Subject: DISAPPROVAL OF IDE

Re: G970088
Sullivan Excimer Laser System (Nevyas Model)
Indications for Use: LASIK for Myopia (-0.5 to -22 Diopters with up to -7 D
Astigmatism)
Dated: March 18, 1997
Received: April 8, 1997

Re: G970088/A1 and A3
Device name: Sullivan Excimer Laser System (Nevyas Model)
Dated: July 3 and 21, 1997
Received: July 8 and 22, 1997

Re: G970088/A1, A3 and A4
Sullivan Excimer Laser System (Nevyas Model)
Indications for Use: LASIK for Myopia (-0.5 to -6.75 Diopters with up to -7 D
Astigmatism)
Dated: July 3, 21, and 29, 1997
Received: July 8 and 22, and August 1, 1997
HCFA Reimbursement Category: A2 (for procedures to request re-evaluation of the
categorization decision, please see the appropriate enclosure)
Annual Report Due: August 7, 1998

Cumulative Ablation Pattern with CI Treatment

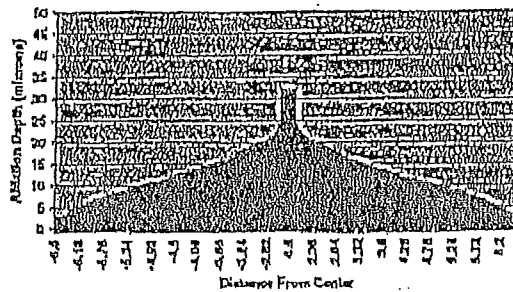
c. The pattern depicted below is from page 153 of your submission and shows theoretically the cumulative effect of a -3.0 diopter ablation using your multizone, multipass ablation algorithm.

As seen in the diagram, it appears that the central 2 mm of the ablation is flat (uncorrected), with steep slope (approximately infinite) for about 25% of the ablation depth (8 microns out of 32 microns), then continuing with more modest slope out to 6.6 mm. Please explain:

- i. During vision with narrowed pupils at 2 mm diameter, is the refraction of the cornea the same as prior to surgery (since that area did not receive a modification of the curvature)?
- ii. During vision with pupils greater than 2 mm diameter, will glare and halo be significantly increased?
- iii. Please relate this theoretical pattern to your profilometry measurements and explain any differences.
